Chapter 2 Response to Comments

Table 2-1: Public Comments Received on the Recirculated DSEIR

Figure 1. Comparison of project-level NO_x emissions as represented in the 2008 EIR and 2017 DSEIR.⁴

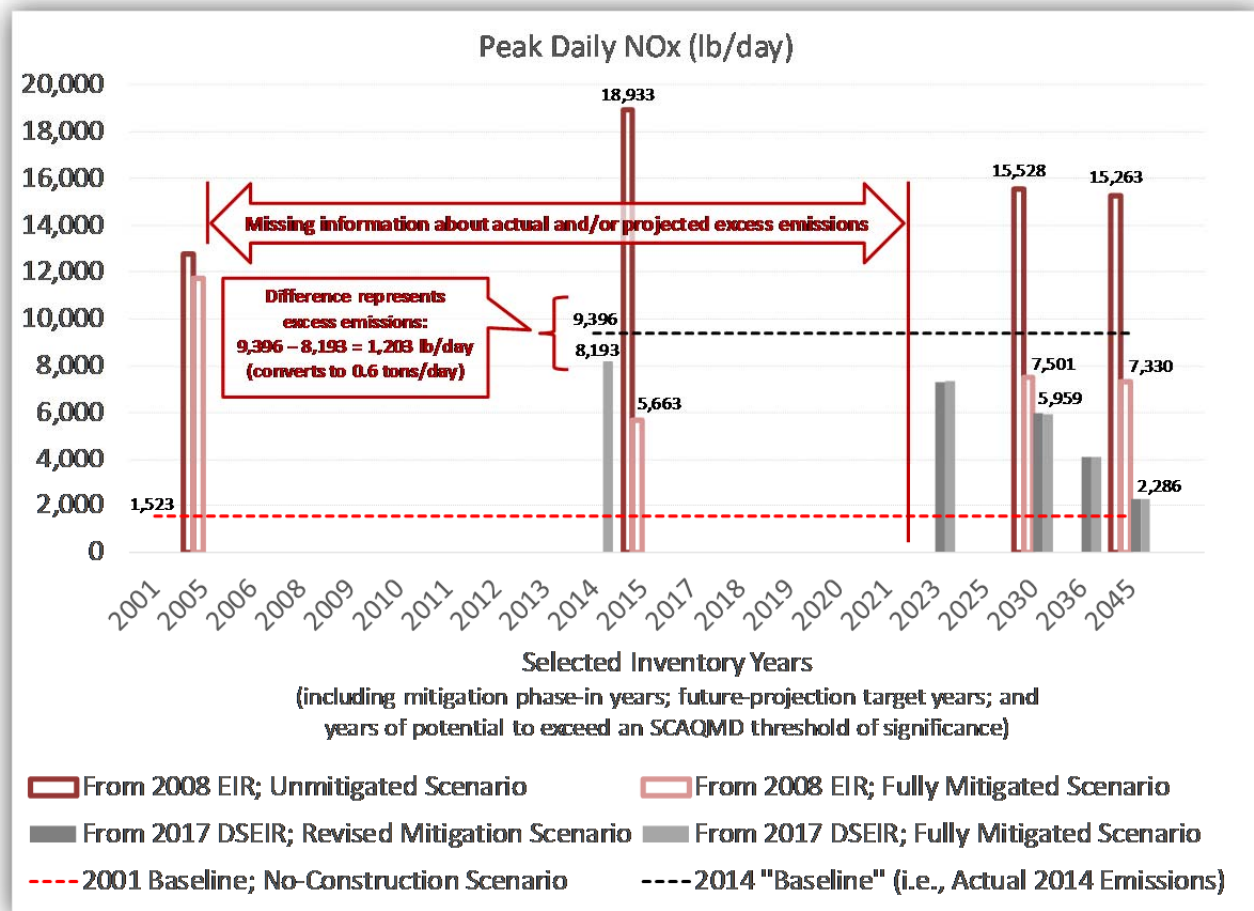
- **Ignoring the illegal excess emissions between 2005 and 2025**, the 2017 DSEIR suggests that by 2023 through 2045, the proposed revised implementation plan will be equivalent to the fully mitigated scenario. (Compare "■ 2017 DSEIR; Revised Mitigation Scenario" to "■ 2017 DSEIR; Fully Mitigated Scenario".) **However, this conclusion is not sufficiently supported in the 2017 DSEIR due to the technical deficiencies discussed through the remainder of this document.**

Figure 3. Contributions of major source categories to project-level 2014 annual emissions of (a) NO_x, (b) PM_{2.5}, (c) DPM emissions, and (d) PM₁₀ emissions.

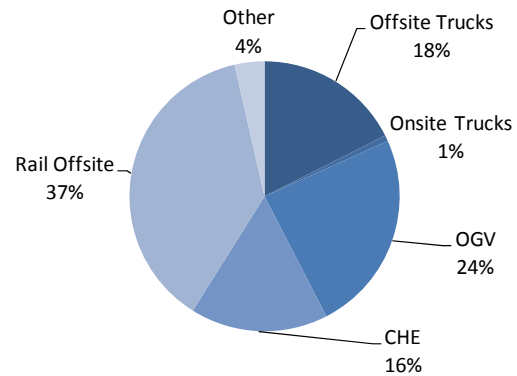
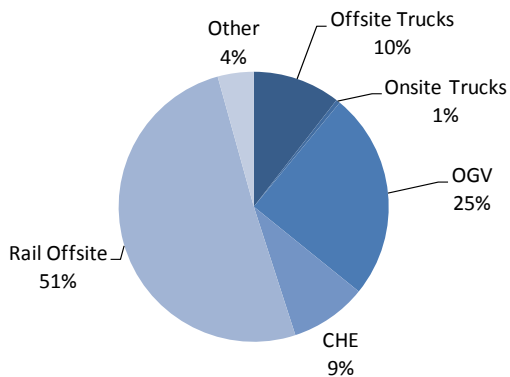
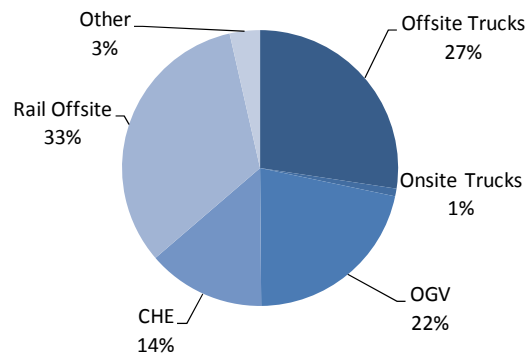
Selected mitigation measures affecting heavy-duty drayage trucks, hoteling of ocean-going vessels, top-pick cargo handlers, and rubber-tired gantry cranes (RTGs) were reviewed in greater detail. These emissions sources were selected for closer review because (a) they contribute significantly to the 2017 emission inventories (see [Figure 3](#)) and/or (b) the full implementation of approved mitigation measures would have yielded relatively large emissions benefits. The mitigation measures affecting these sources are re-stated briefly as follows (identifier numbers from the 2008 EIR appear in parenthesis).

The first part of this comment (Figure 3, page 7 and 8) refers to material presented in a previous draft (the DSEIR). That document has been superseded by the Recirculated DSEIR, in which additional analysis years have been added to the air quality analysis and peak-day emissions have been updated; accordingly, this part of the comment is no longer applicable.

Figure 4. Comparison of alternative estimates of annual PM emissions from on-site trucks.

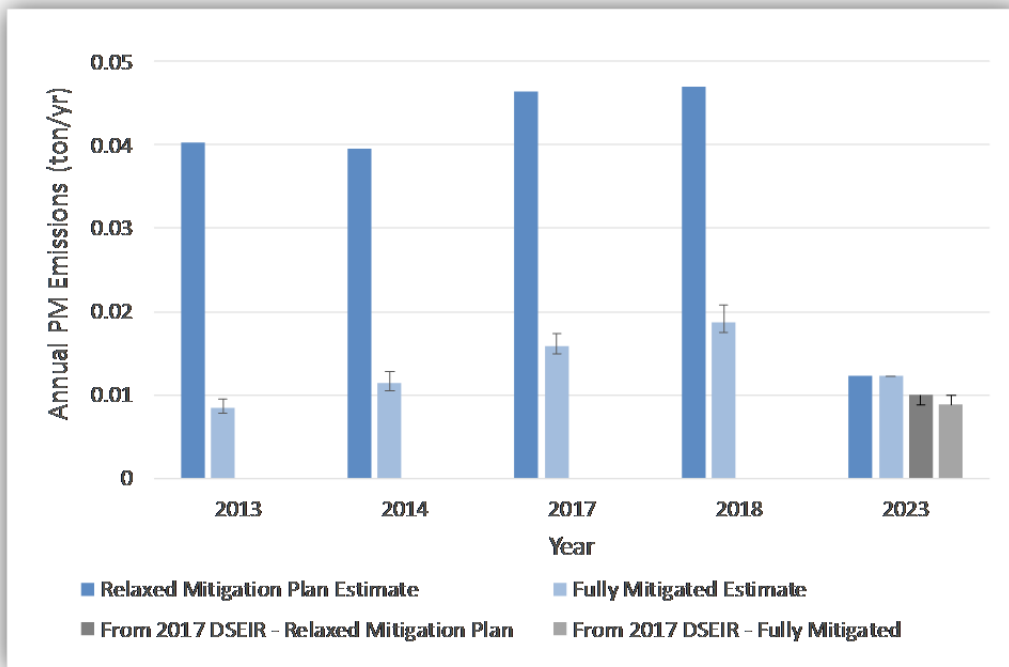
Figures 4 and 5 illustrate alternative estimates of project-level PM and NO_x emissions for heavy-duty trucks operating within the boundaries of the CS Container Terminal Project. Based on best available information, STI staff working under my direction prepared estimates of annual emissions for two scenarios⁵: (a) implementation of MMAQ-20 as approved (“Estimate - Fully Mitigated Plan” in the figures) and (b) implementation as proposed in the 2017 DSEIR (“Estimate - Relaxed Mitigation Plan” in the figures). These estimates cover several calendar years (2013, 2014, 2017, 2018, and 2023); and they are plotted alongside the analogous emissions estimates from the 2017 DSEIR for year 2023—i.e., the only comparable year covered in the 2017 DSEIR. **STI’s estimates show the excess emissions from heavy-duty trucks occurring, while the information from the 2017 DSEIR either omits (2013-2018) or even suggests no benefit from the approved mitigation plan in 2023.**⁶ Note that by ignoring years earlier than 2023, the 2017 DSEIR takes advantage of an EMFAC-projected conversion of the vehicle fleet in 2023 to modern emissions standards—after which time, diesel and LNG trucks are expected to emit PM at similar rates. In other words, federal or statewide regulations are expected to yield a large drop in PM emissions from diesel vehicles in 2023, regardless of which mitigation scenario is in effect at the CS Container Terminal. However, the lack of NO_x benefits projected for 2023 in the 2017 DSEIR is unsupported. LNG vehicles are known to emit NO_x at a much reduced rate compared to diesel vehicles. However, the **NO_x emission factors used in the 2017 DSEIR for heavy-duty trucks are contrary to published literature.** Not only are the emission factors for diesel-fueled trucks set to be equal to those for LNG-fueled trucks in the 2017 DSEIR, but the NO_x emission factors for heavy-duty trucks increase from 2023 to 2045 (see **Figure 6**). Both of these patterns are contrary to published literature.⁷

Figure 7. Comparison of various peak-day NO_x emissions scenarios for hoteling of OGVs as represented in the 2008 EIR and 2017 DSEIR.⁴

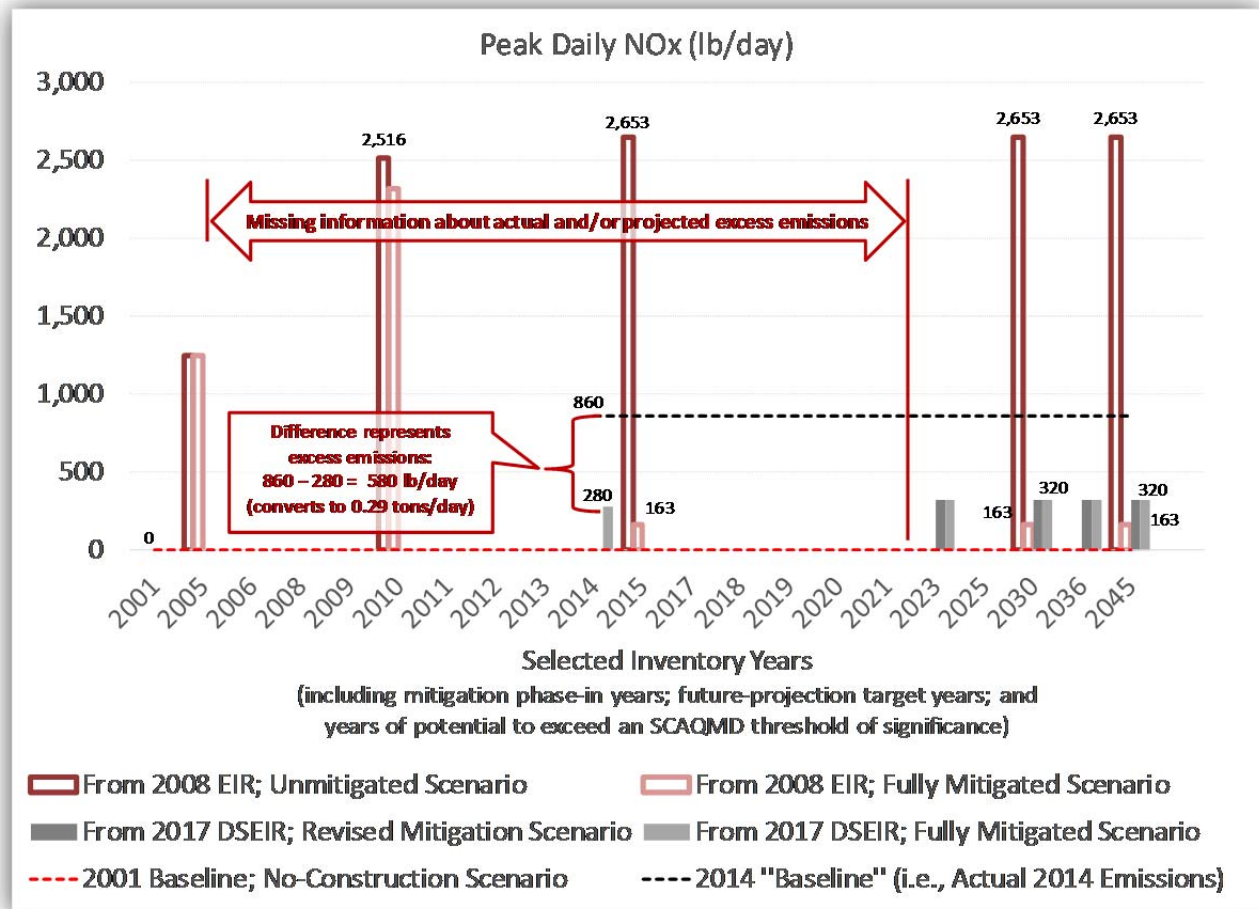
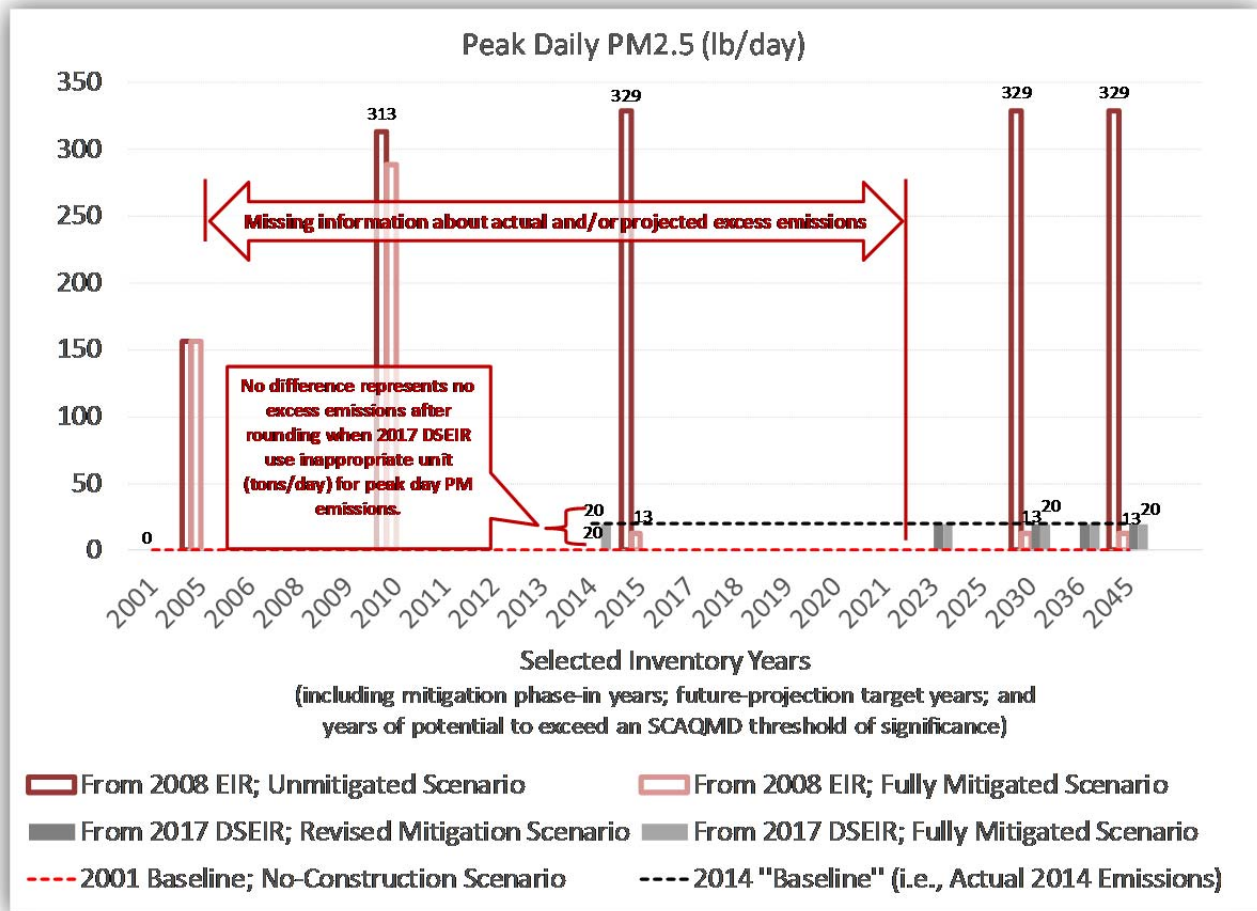
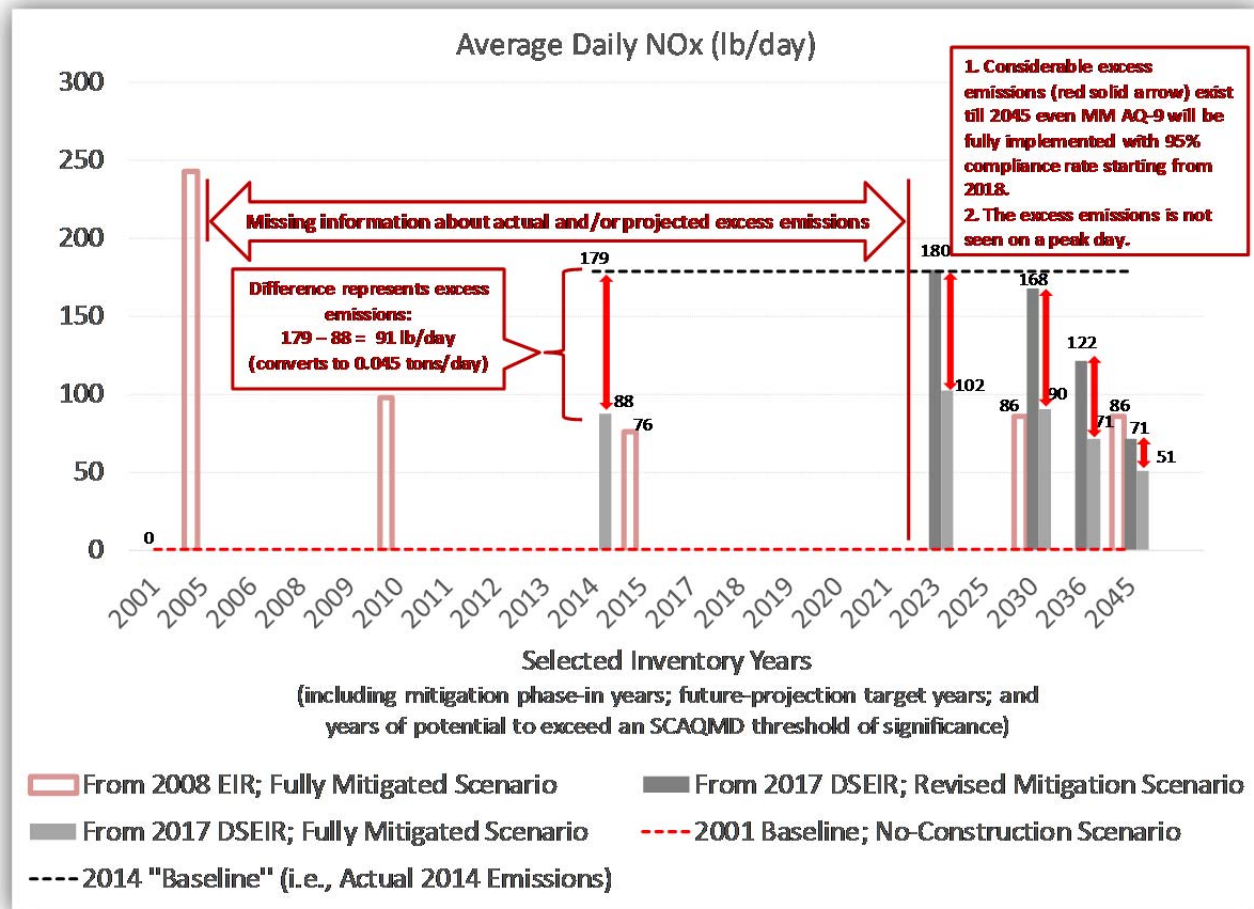
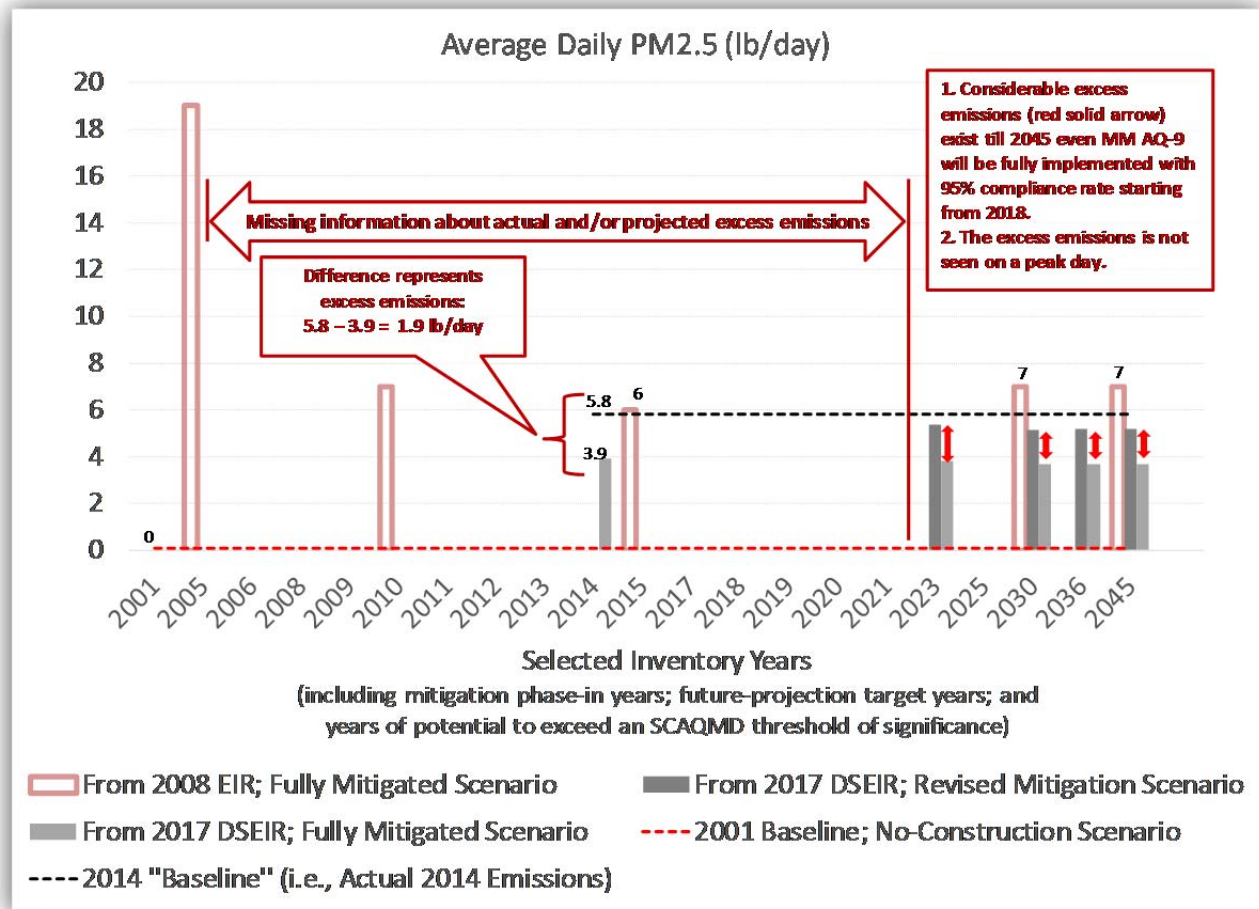
Additional examples of the contradictory, unsubstantiated, and inconsistent statements, assumptions, and calculations in the air quality sections of the 2017 DSEIR include:

Figure 11. Comparison of various NO_x emissions scenarios for cargo handling equipment as represented in the 2008 EIR and 2017 DSEIR.⁴

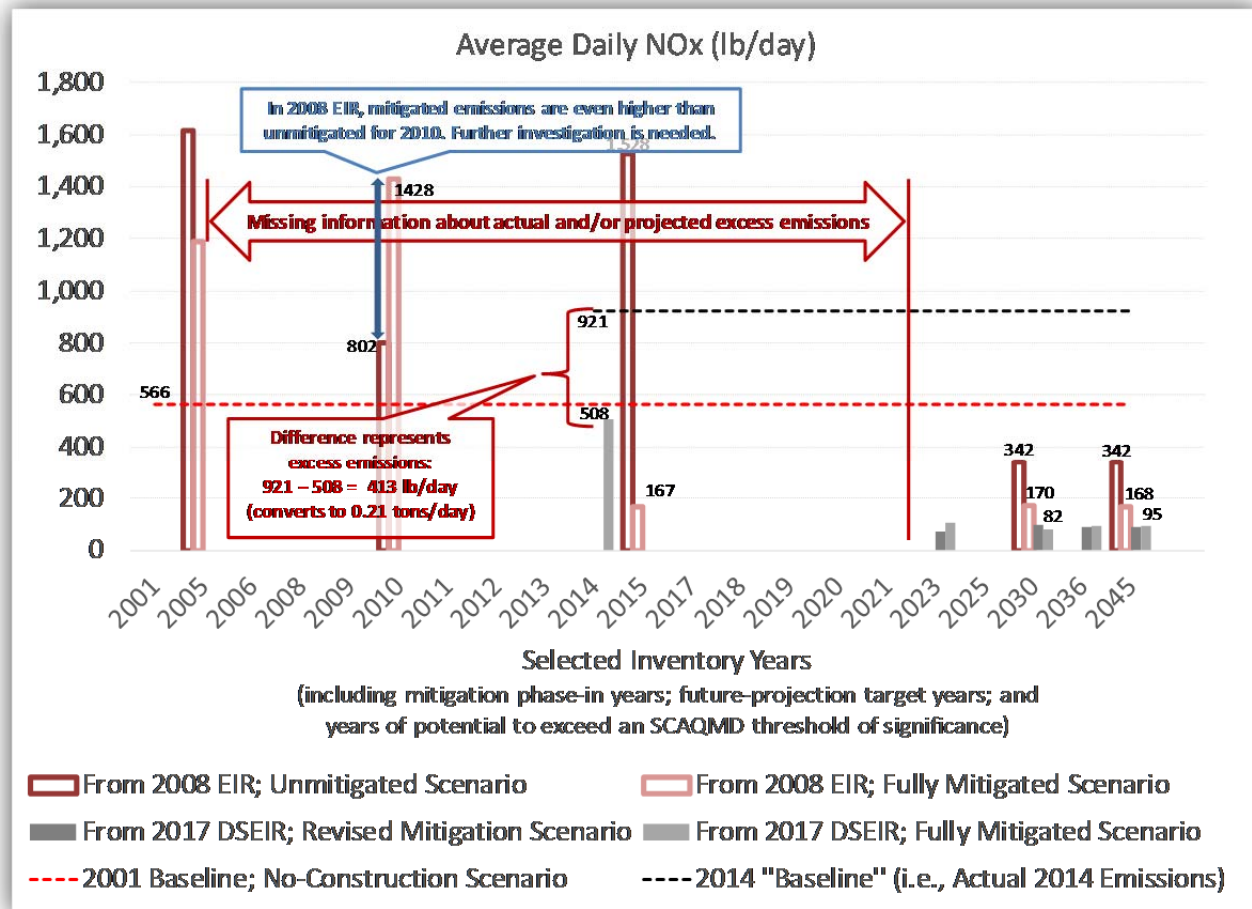
- Figures 11 and 12 illustrate project-level, peak-day NO_x and PM_{2.5} emissions for cargo-handling equipment. An inconsistency issue was found in the 2008 EIR for analysis year 2010 where emissions for the approved mitigation scenario are greater than the emissions for the unmitigated scenario. If emissions from the 2008 EIR are used as a basis for comparison, estimates for these two scenarios need to be verified.

Figure 12. Comparison of various PM_{2.5} emissions scenarios for cargo handling equipment as represented in the 2008 EIR and 2017 DSEIR.⁴

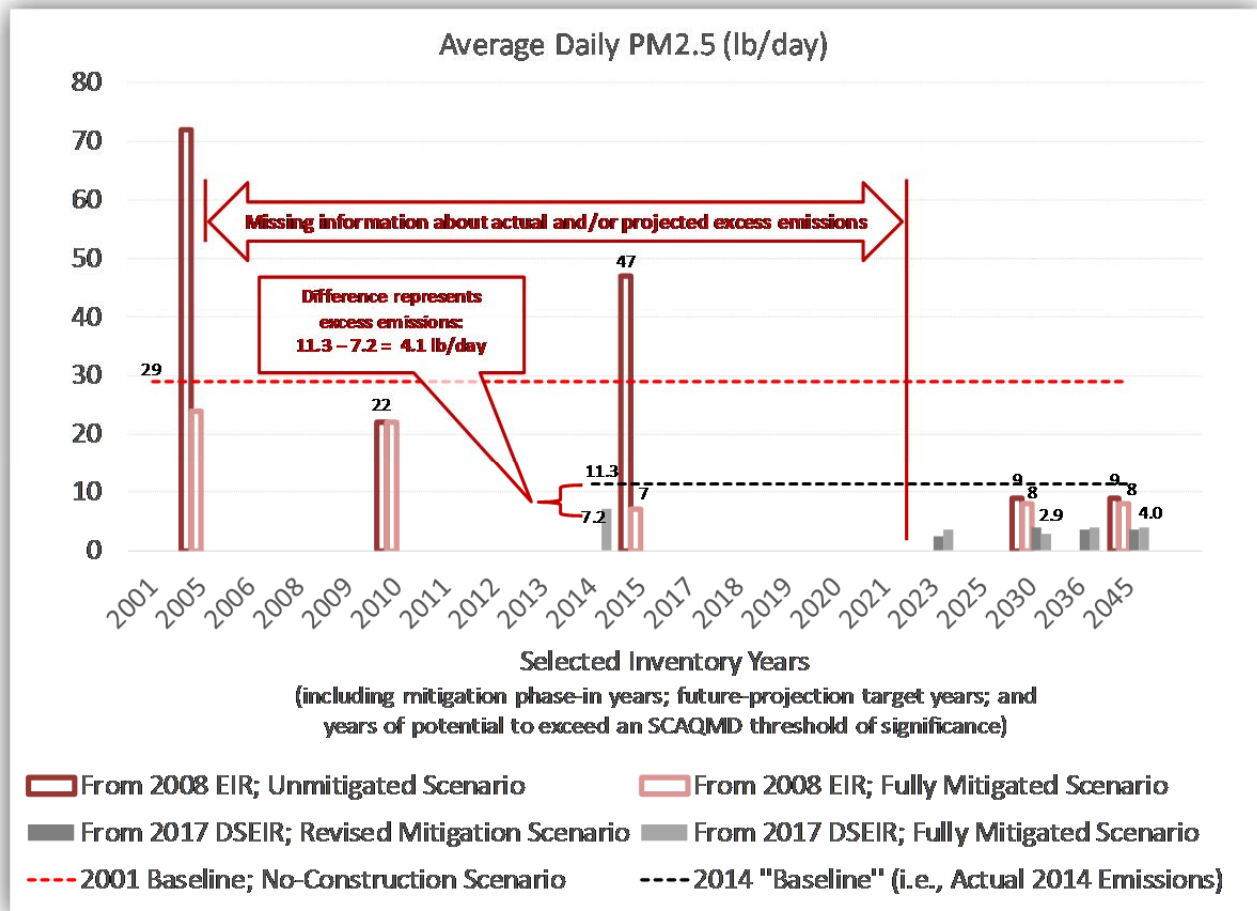
- An inconsistency was found in the 2008 EIR itself when comparing the approved mitigation scenario to the unmitigated scenario. For example, the 2010 NO_x emissions from cargo handling equipment associated with the approved mitigation scenario were actually higher than those for the unmitigated scenario (when clearly the opposite is expected). If the 2008 EIR is selected to be used as a reference to compare scenarios in the future, then further investigation and validation of the 2008 emissions estimates is warranted. (See discussion beginning on page 17 and Figure 12.)
